**TAYLORSVILLE-BENNION IMPROVEMENT DISTRICT  
3900 SOUTH SEWER LIFT STATION REHABILITATION**  
CRS Project No. 10023C

## **ADDENDUM No. 1**

**Issued:** May 11, 2011

**4. C-104**

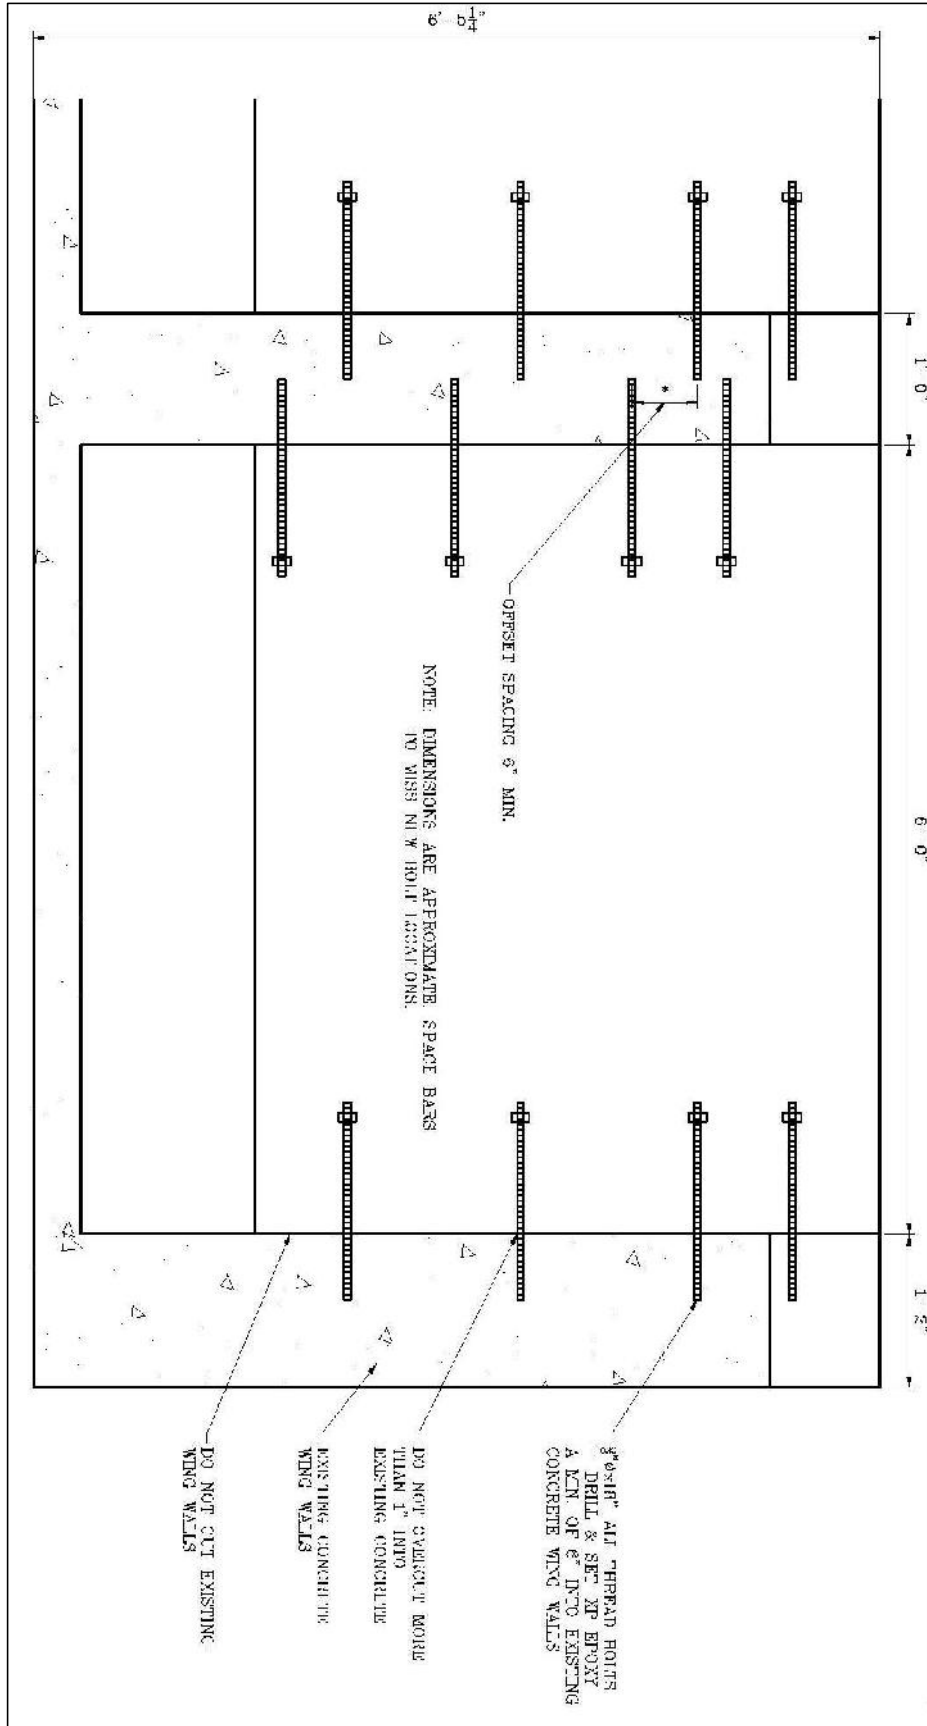
- a. Retaining wall detail callout shall change from 13/S-100 to 15/S-100.

**5. M-101**

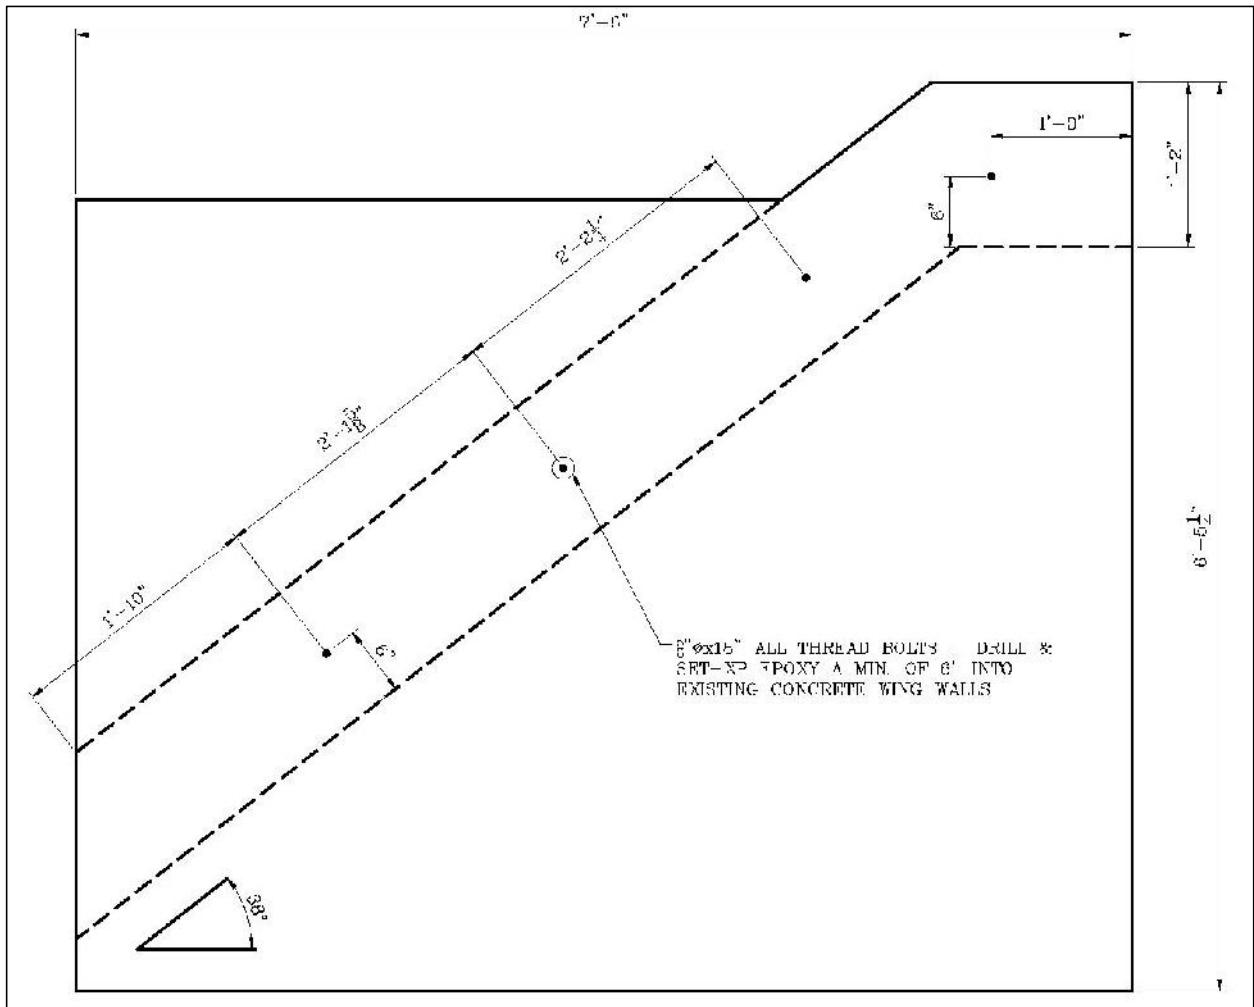
- a. From BASIN & TROUGH PLAN VIEW; Concrete Pillow Block detail callout change from 13/S-101 to A/M-101.
- b. Detail A/M-101: Replace DETAIL A - UPPER BEARING PILLOW BLOCK with attached **DETAILS A1, A2, and A3**
- c. Detail B/M-101: Replace DETAIL B – LOWER BEARING PILLOW BLOCK with attached **DETAIL B**
